City of Biddeford
Planning Board
September 29, 2021 6:00 PM City Hall
Council Chambers, & via ZOOM
Sep 29, 2021 06:00 PM Eastern Time (US and Canada)
Topic: Planning Board

- 7.D. Final Site Plan/Subdivision Review and a Public Hearing and make a recommendation to the City Council regarding a proposed Contract Zone for Adams Point, LP and Southern Maine Affordable Housing at 69 Adam's Street (Tax Map 38, Lot 296) to allow for 39 units of multi-family housing in a structure not to exceed 60 feet in height (5 stories) as measured from grade to the highest roof beams of a flat roof, excluding any parapets for elevators, roof access, or the screening of mechanical equipment, and to provide less than 1 parking spaces per unit. Multi-family housing is a permitted use in the underlying zone (MSRD-2).

[4.0 Board Report - Adams Point Final Plan-rv \(929 MTG\).pdf](#)

STOR1 STORMWATER STORAGE AND
OCS1 OUTLET CONTROL STRUCTURE DETAIL

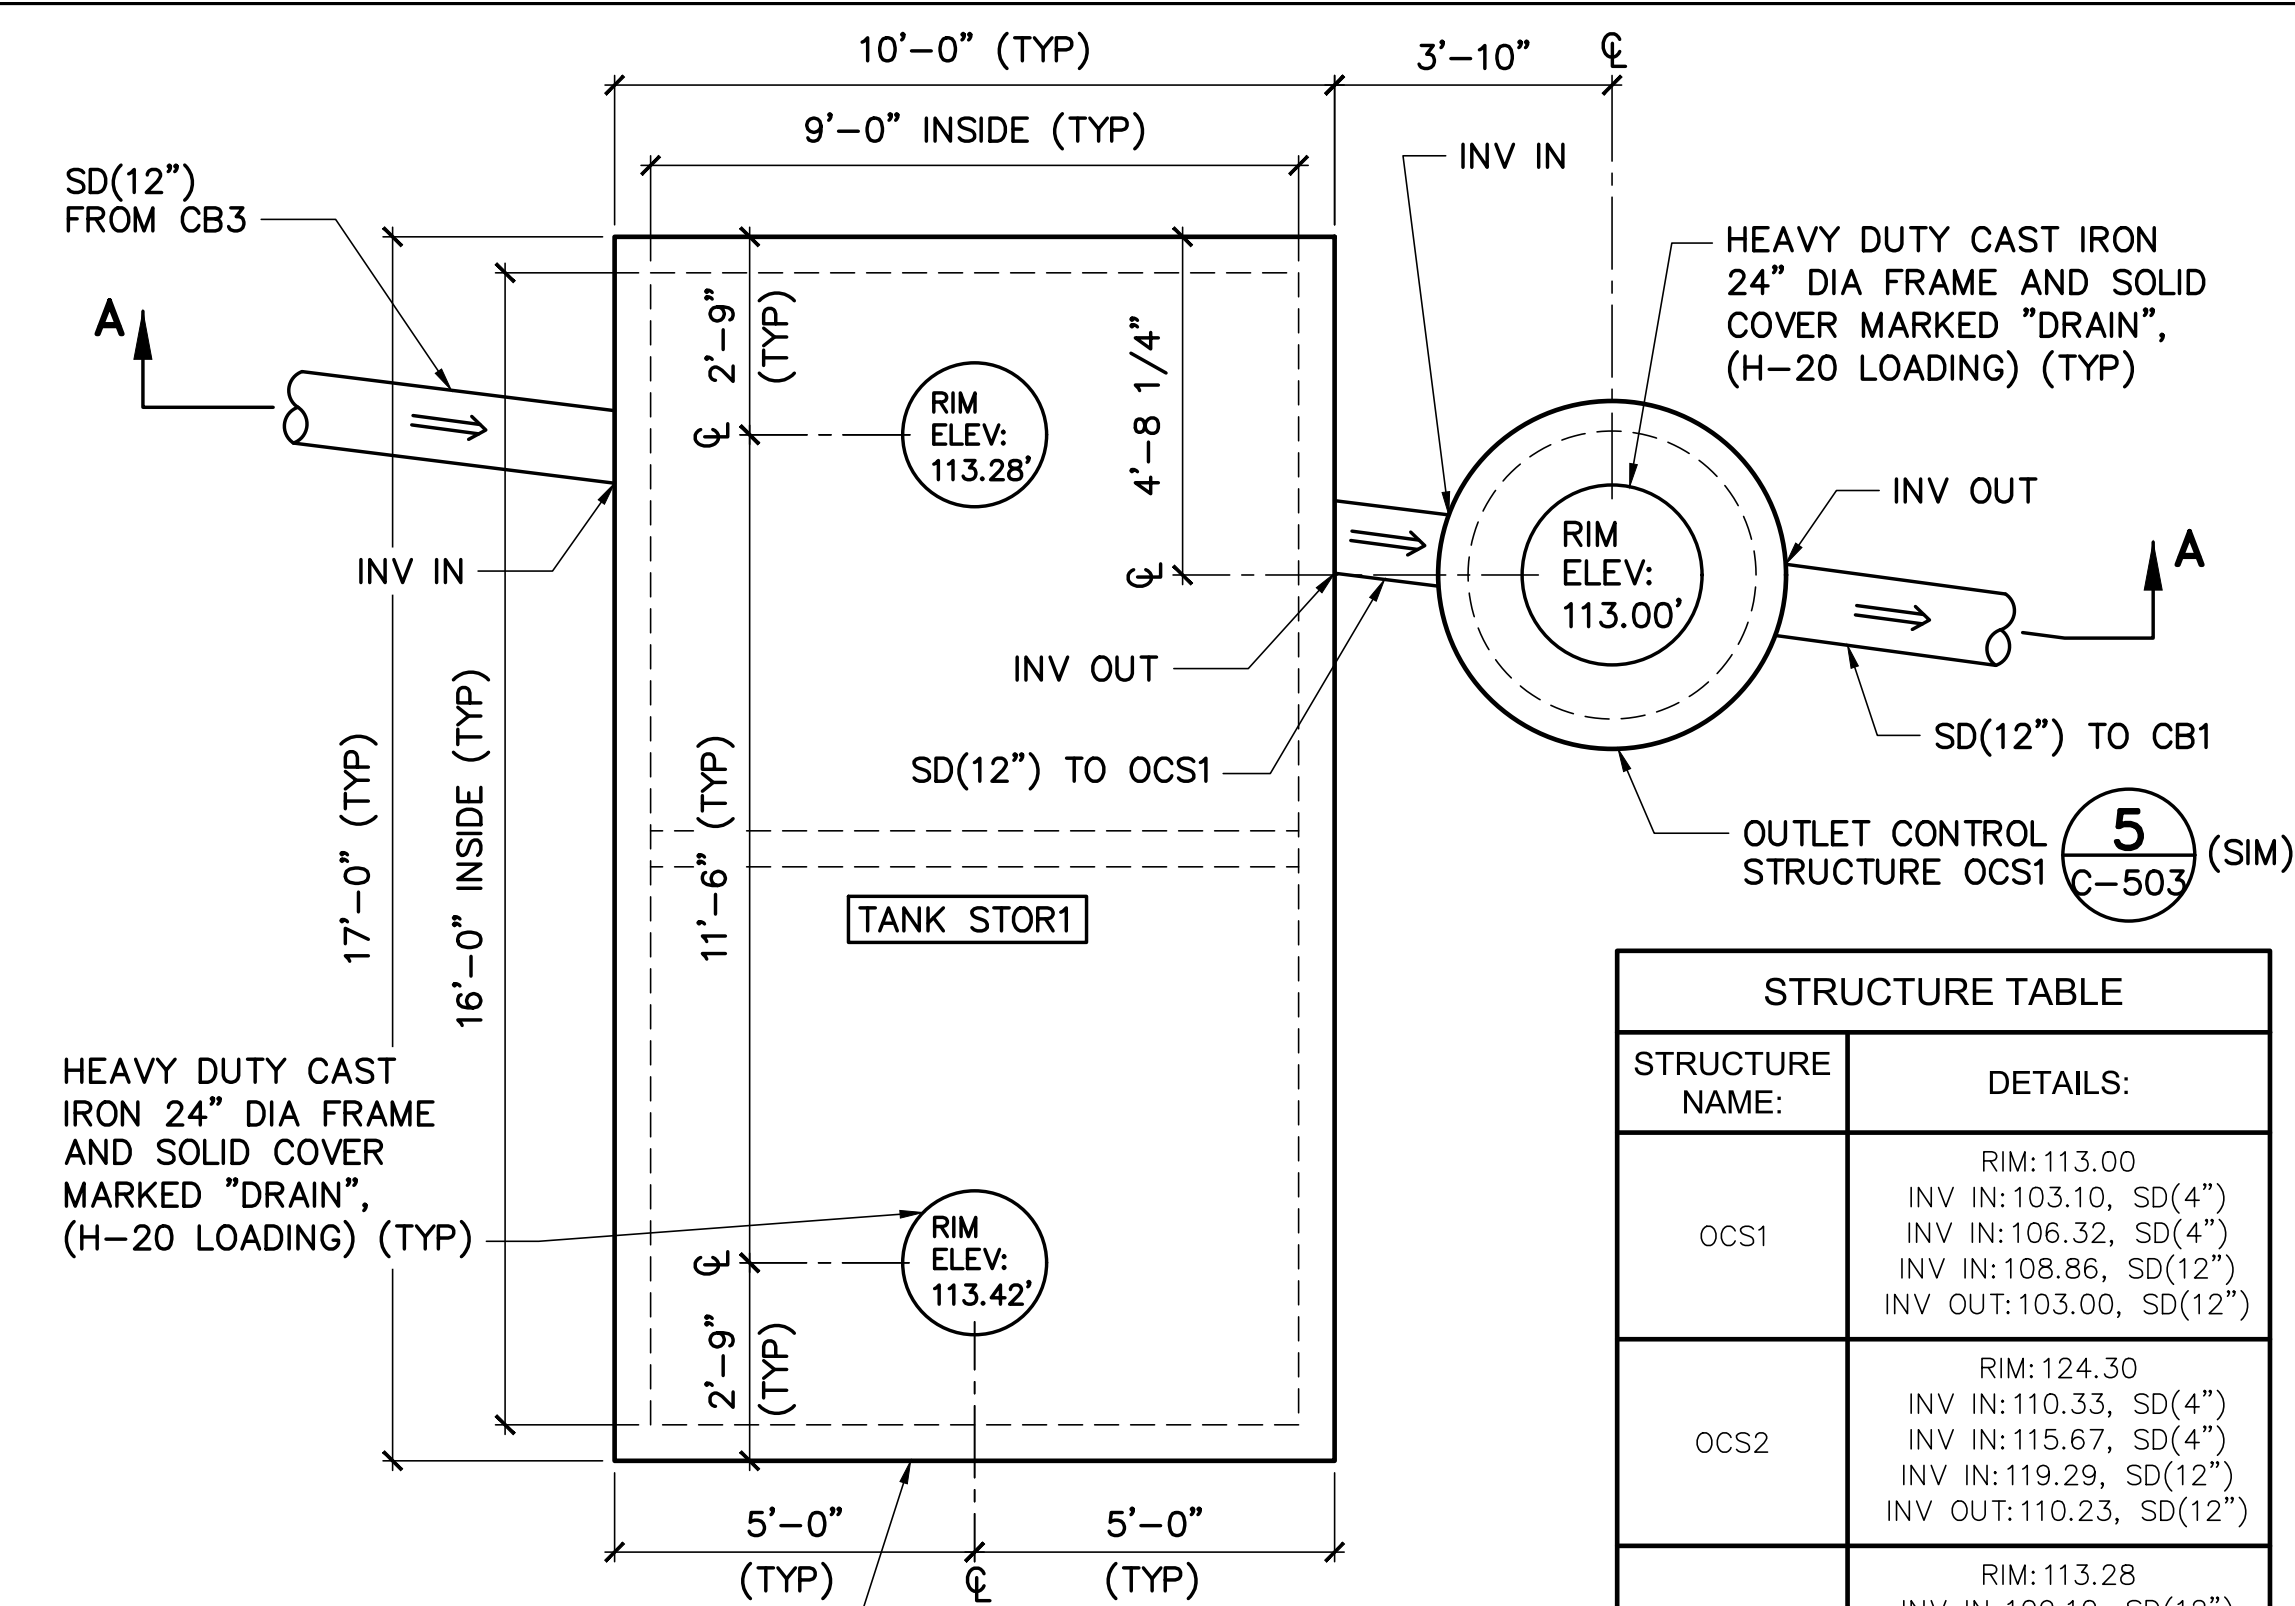
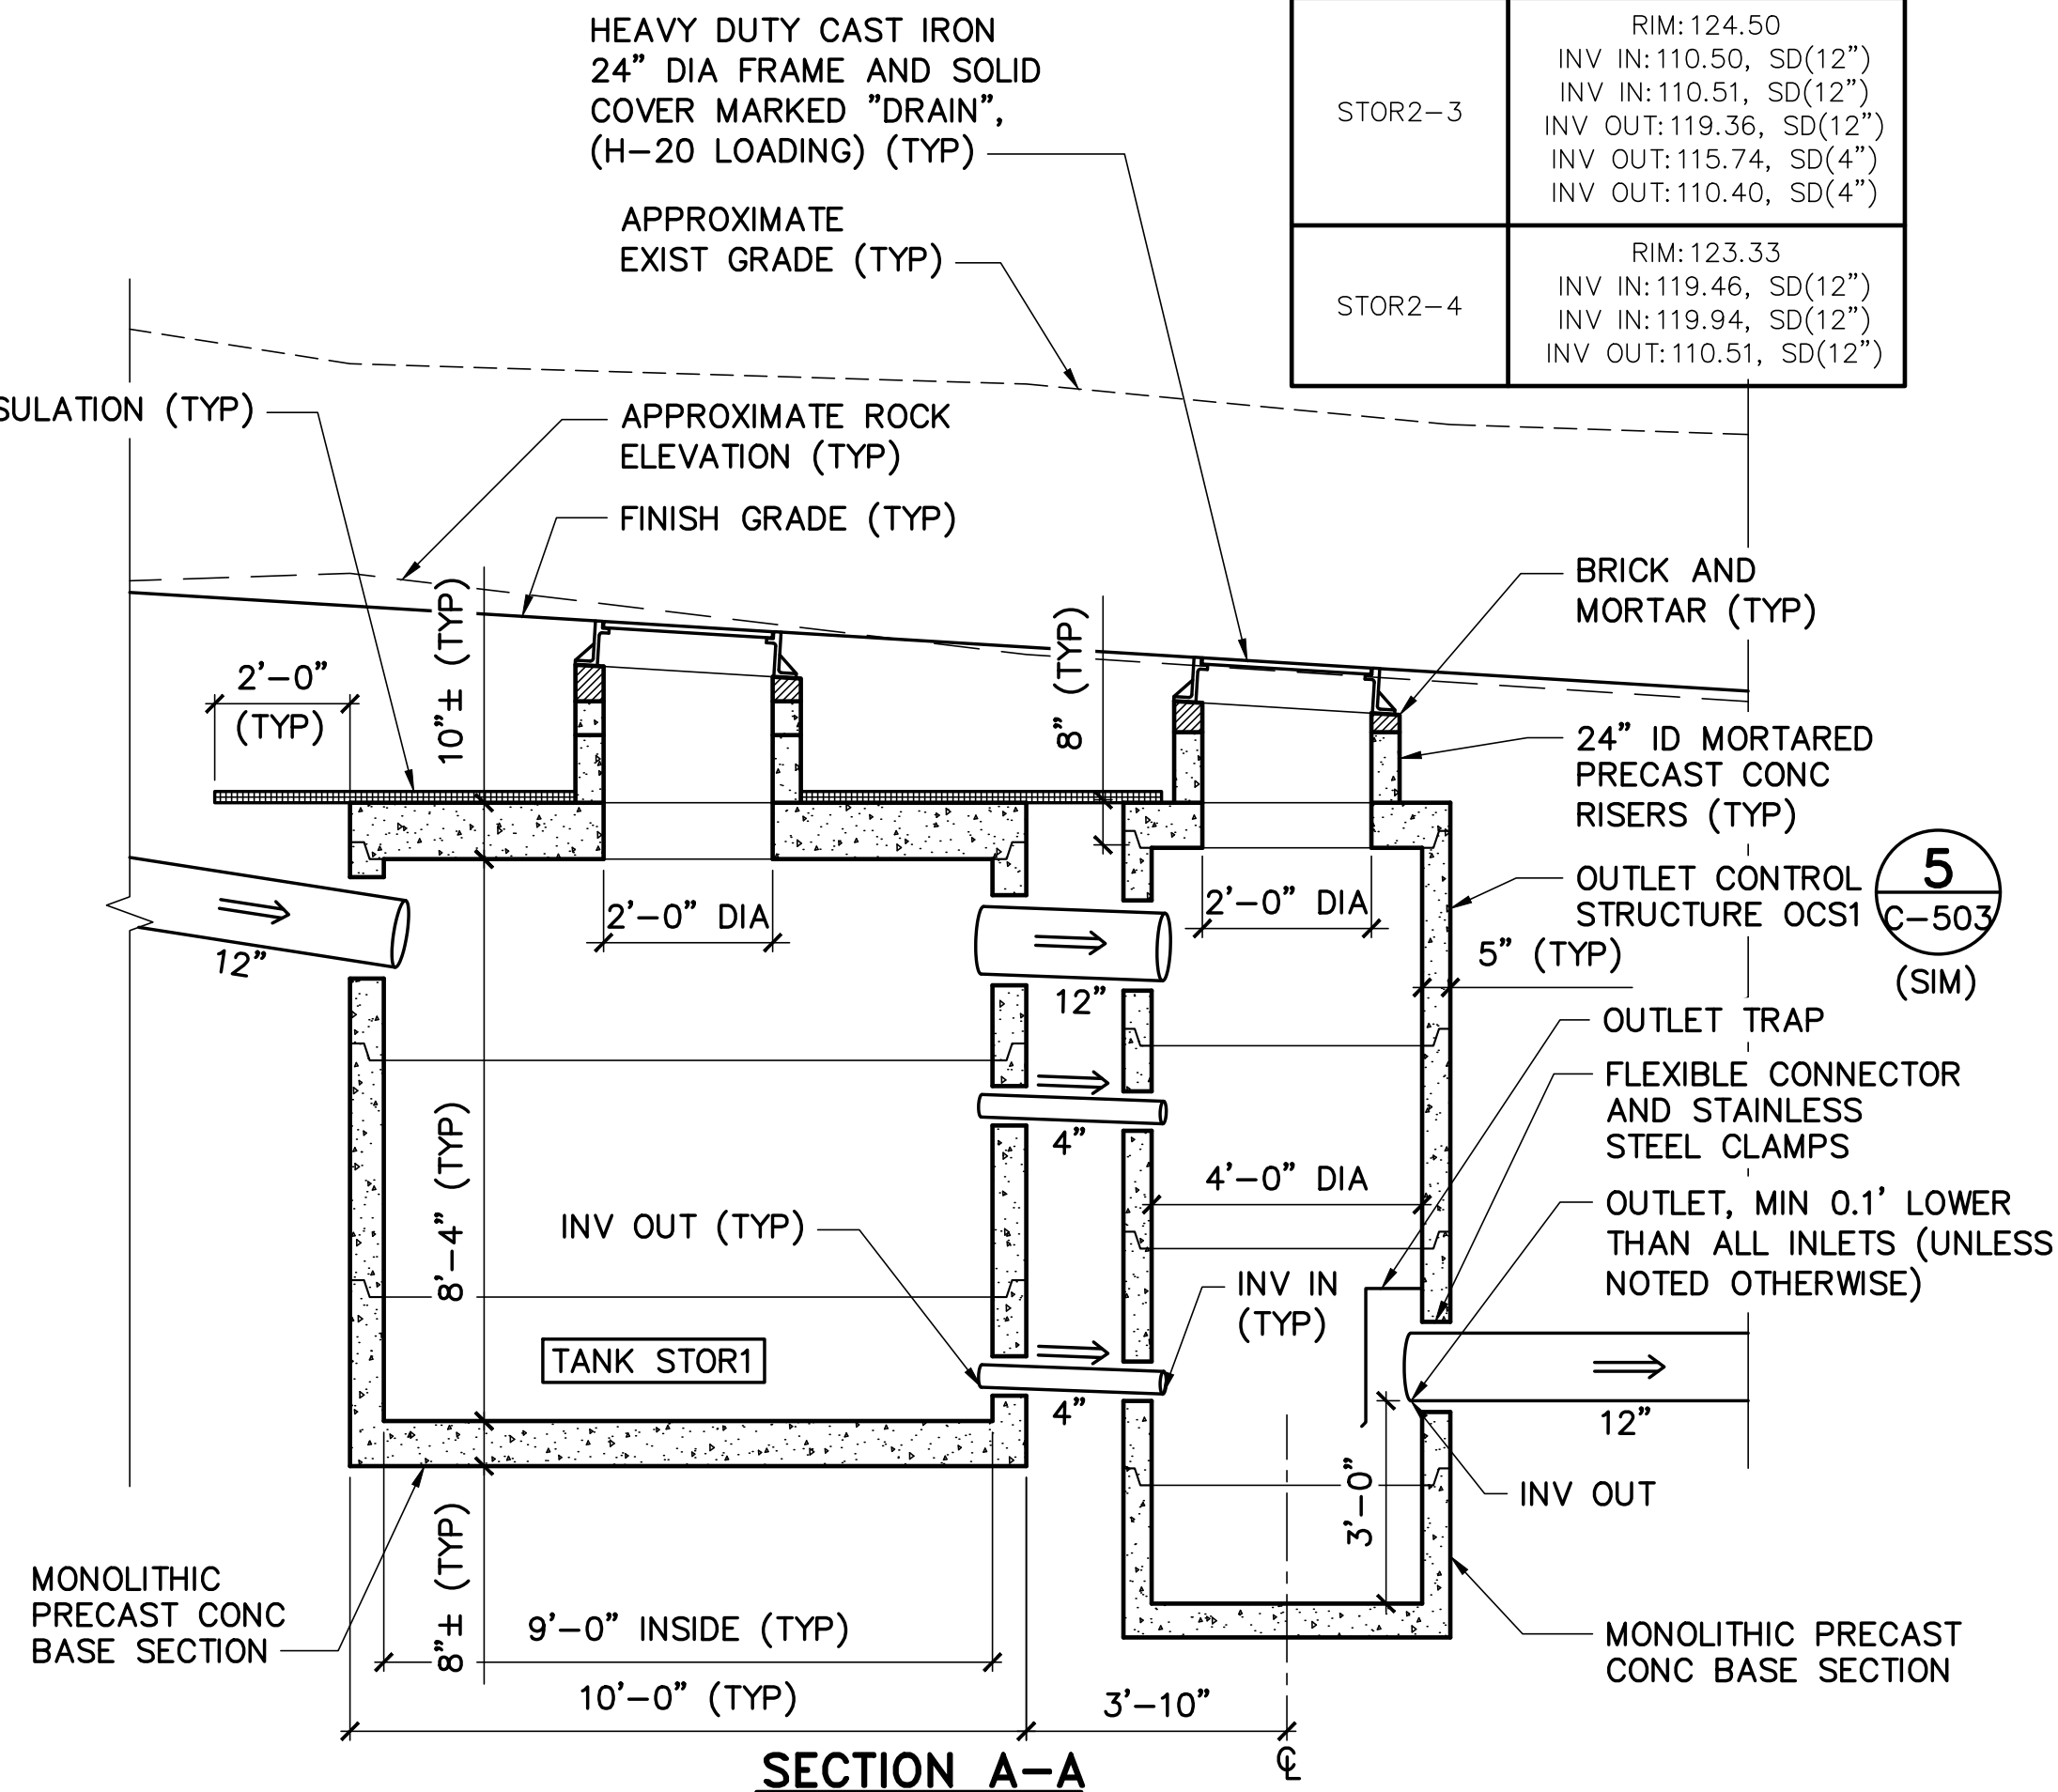
- Sheet C-504

- o Detail 1 – separate details/plans/sections should be provided for each individual detention system (STOR-1 and STOR-2) with proposed rim/invert/bottom elevations identified. **Response: Details for each storage system have been provided.**
- o Manufacturer/model name identified, or standard details provided. **Response: There are no manufacturer specific items and standard details are provided.**

SHEET: 22 OF 22

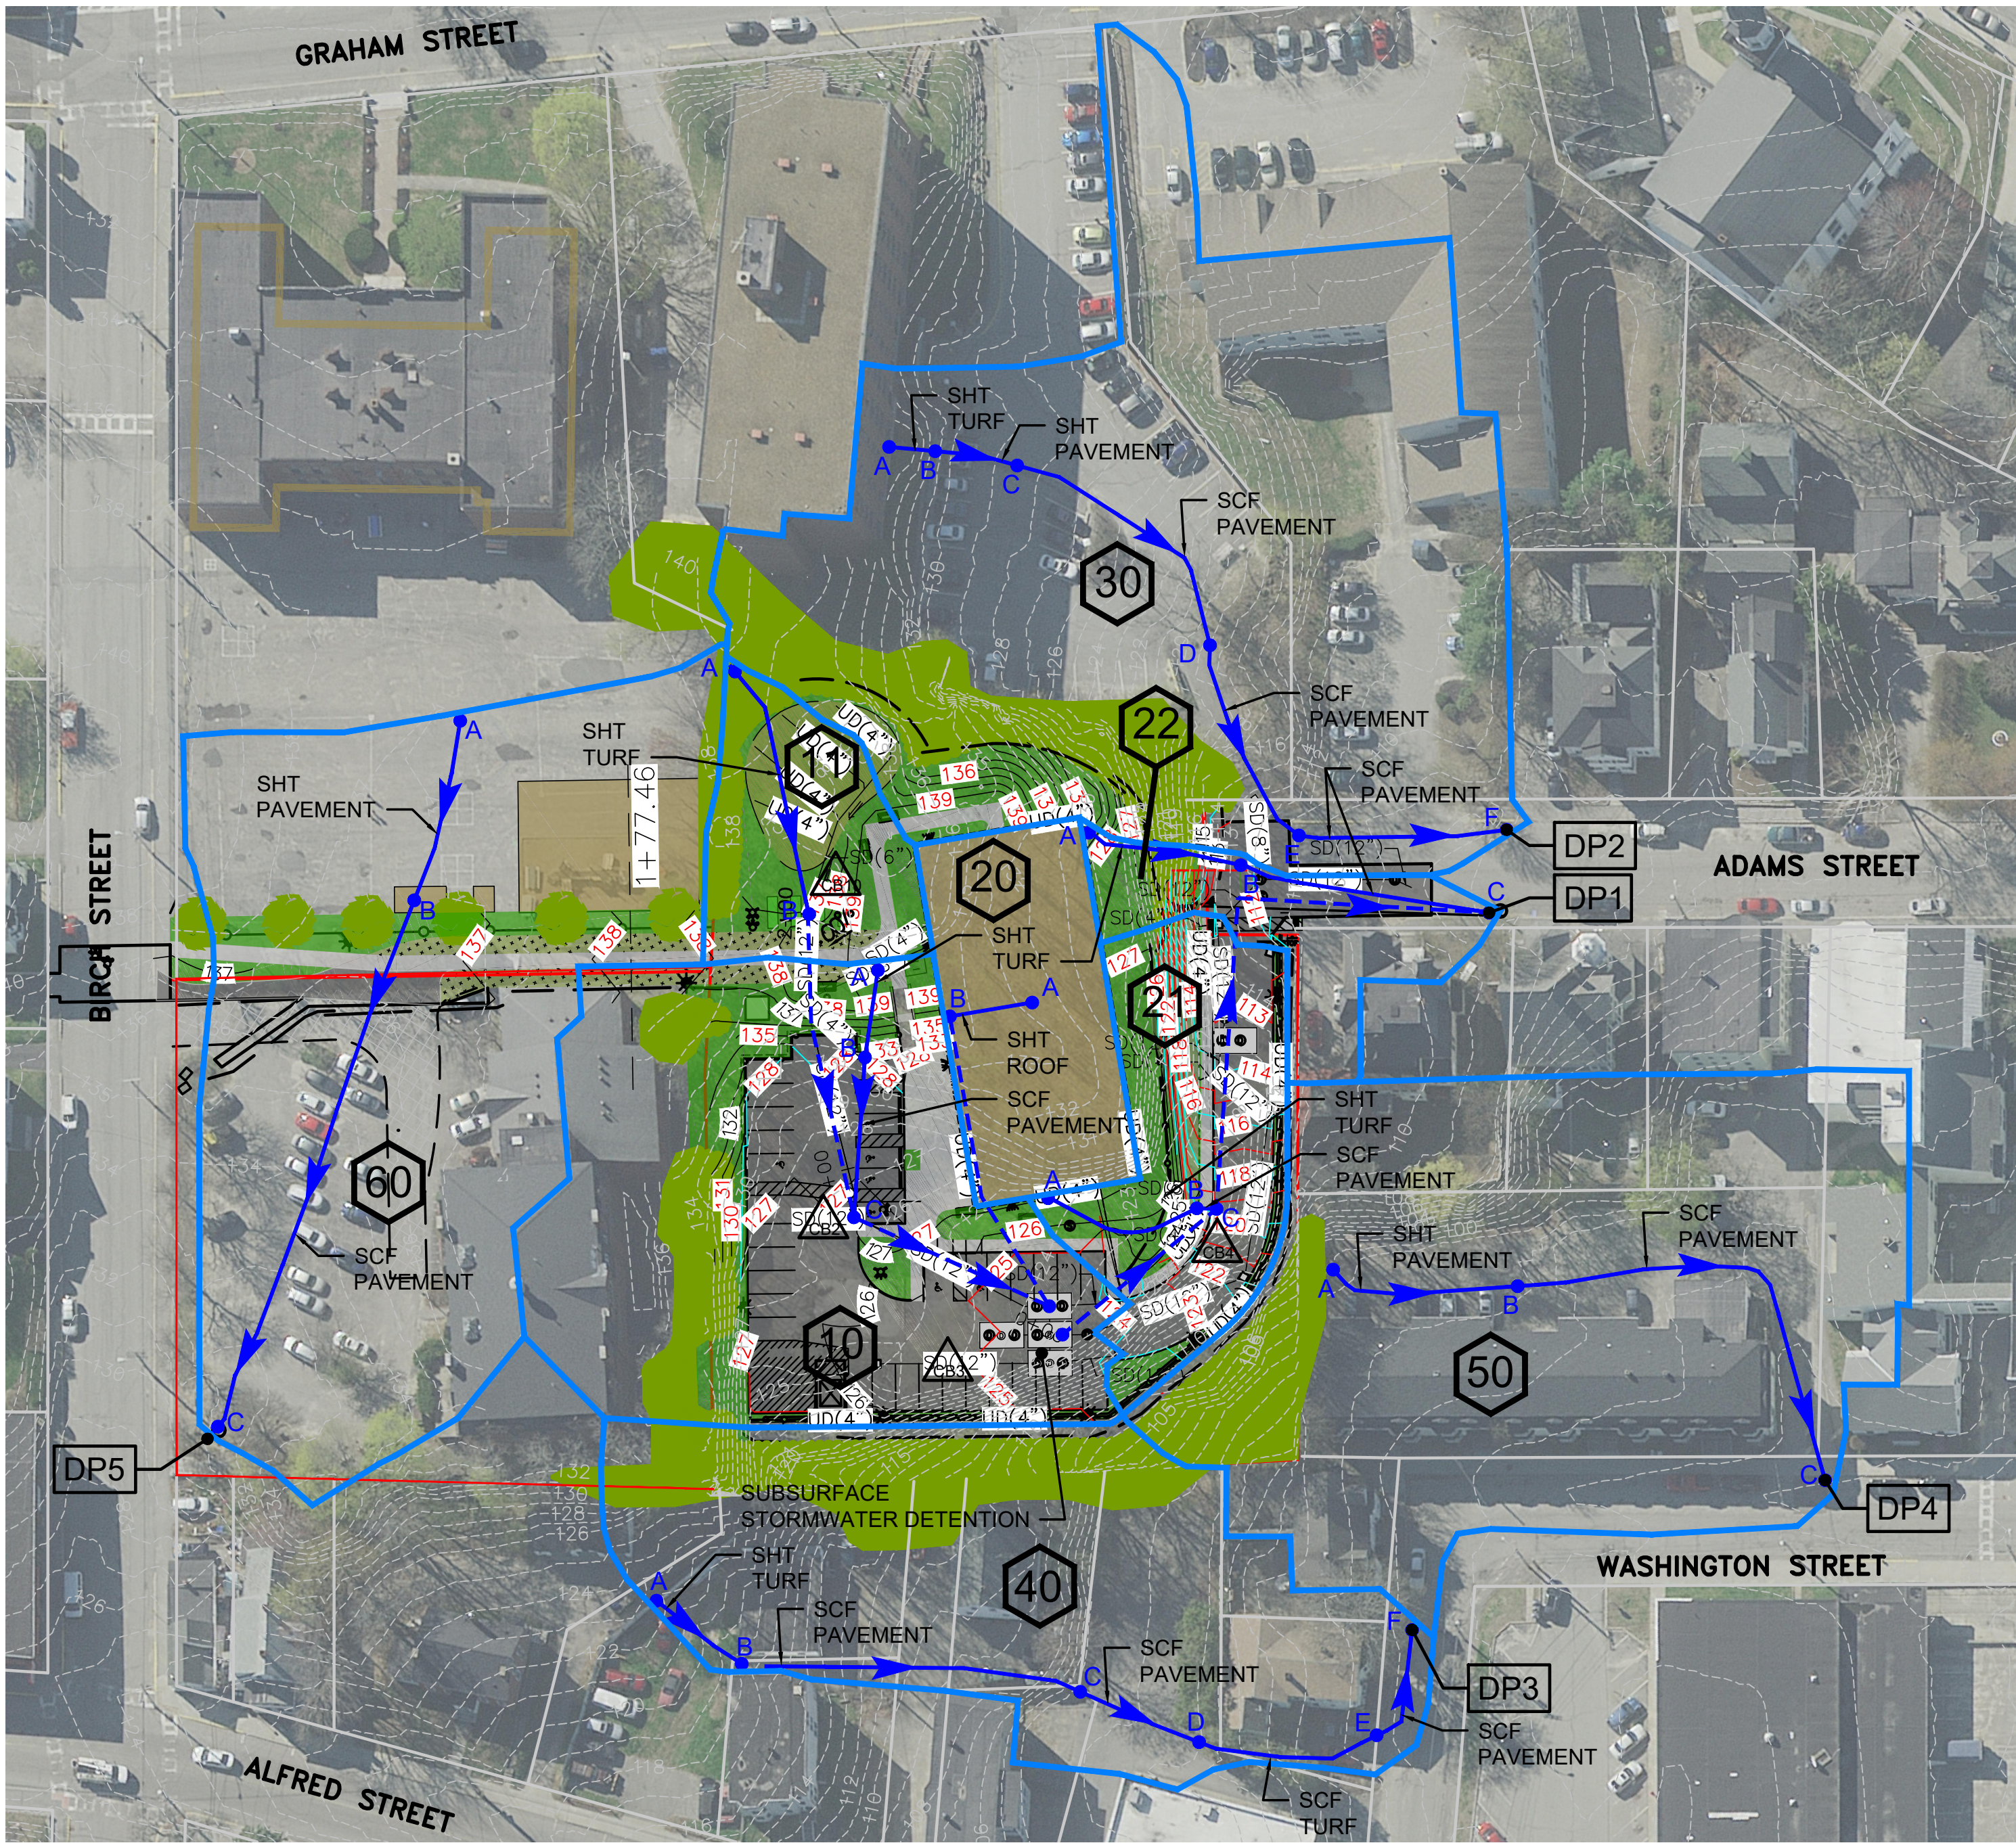
- **Sheet WS101**
